Meeting Agenda

Franklin Municipal Planning Commission

Thursday, October 22, 2015

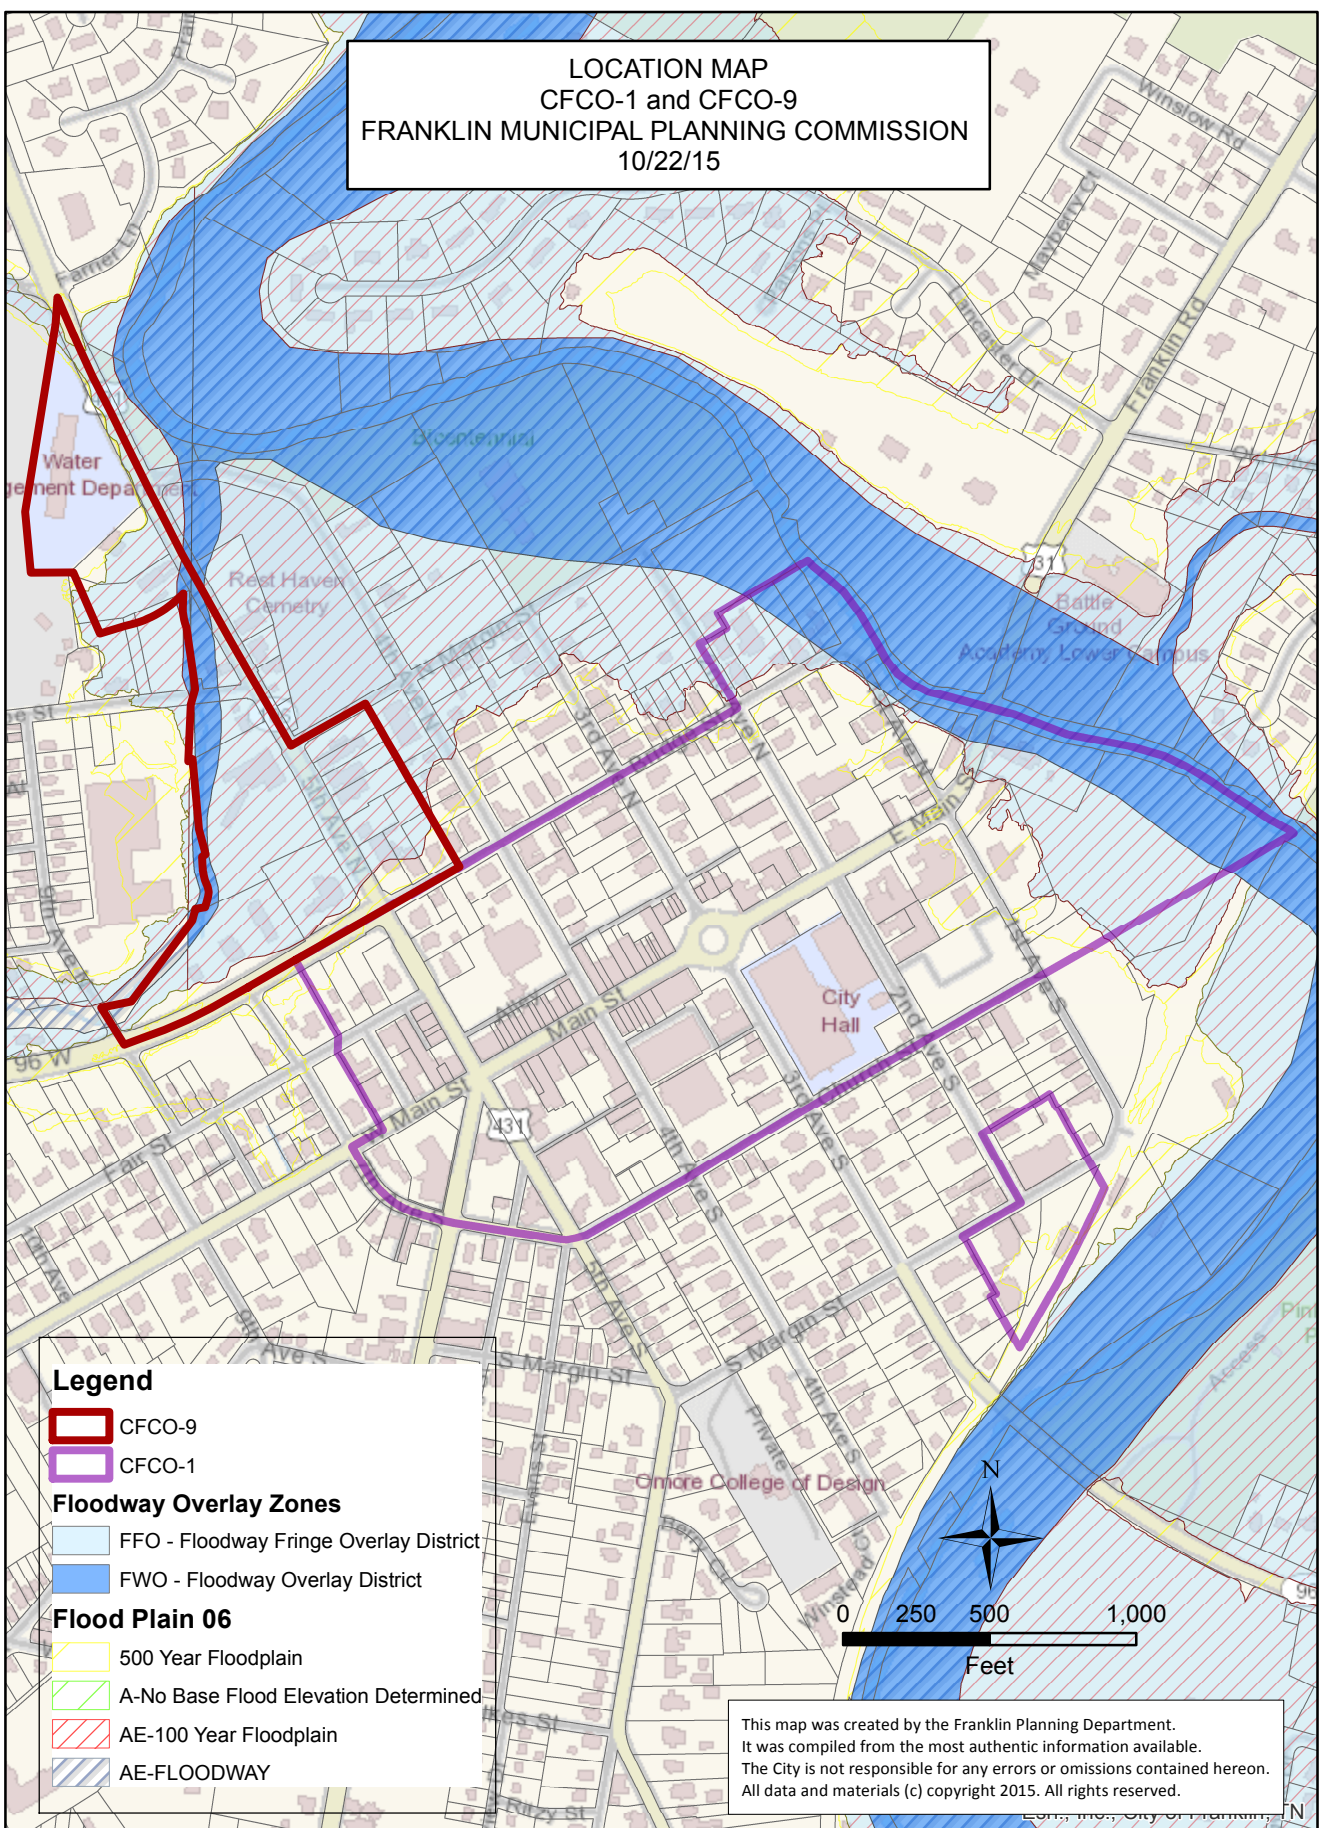
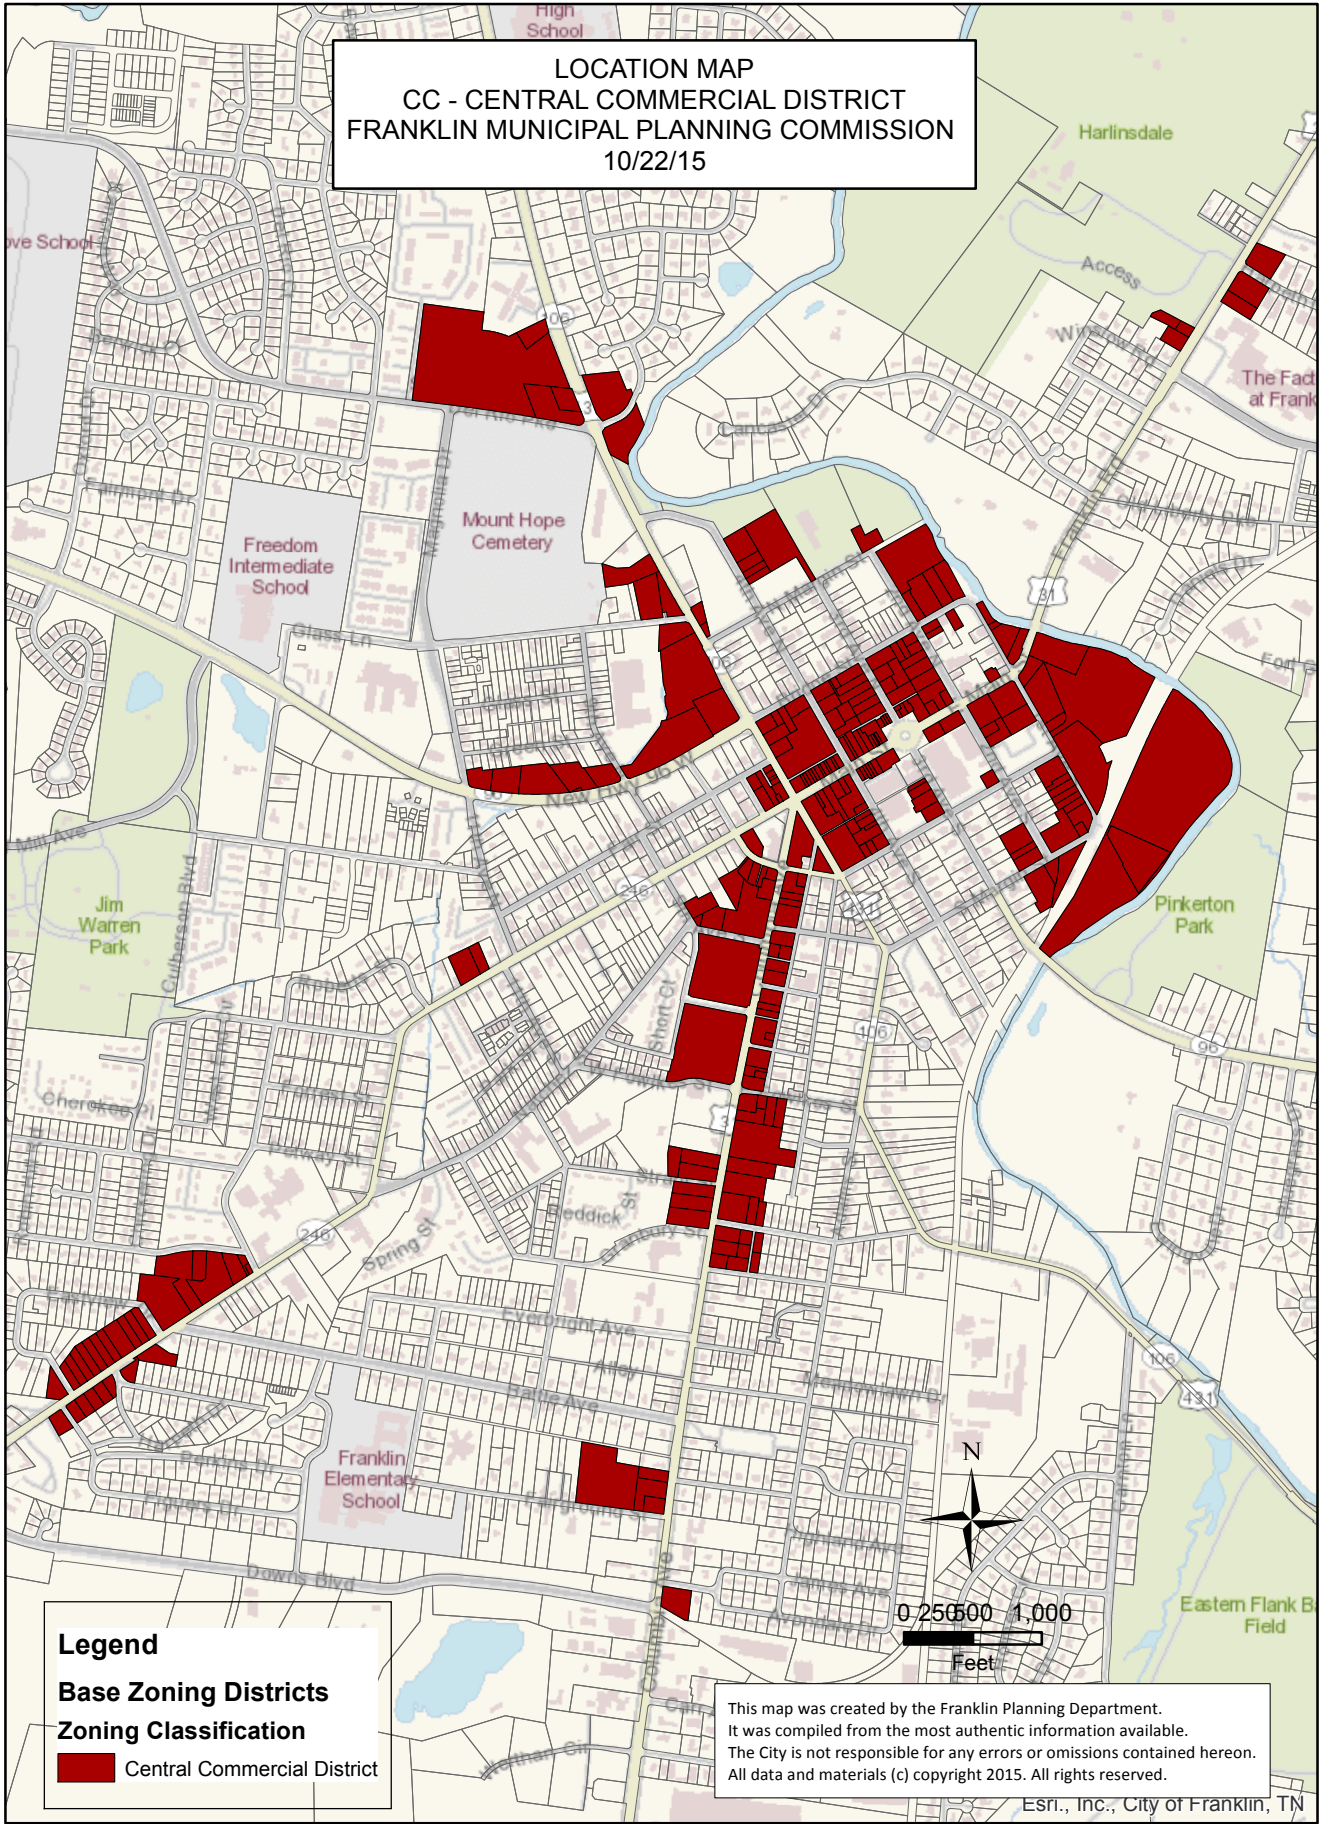
SECTION III. That Chapter 5, Section 5.3, Subsection 5.3.6(3), Figure 5-37 of the Franklin Zoning Ordinance is hereby amended to modify the following illustration and caption text noted with a ~~strike through~~; to add the following text noted in **bold**, and is approved to read as follows:

Figure 5-37: Corner lots on major intersections ~~can be~~ **are in** inappropriate places for automobile fuel sales or similar automobile service and sales uses. See Section 5.3.6(3) for prohibited locations.
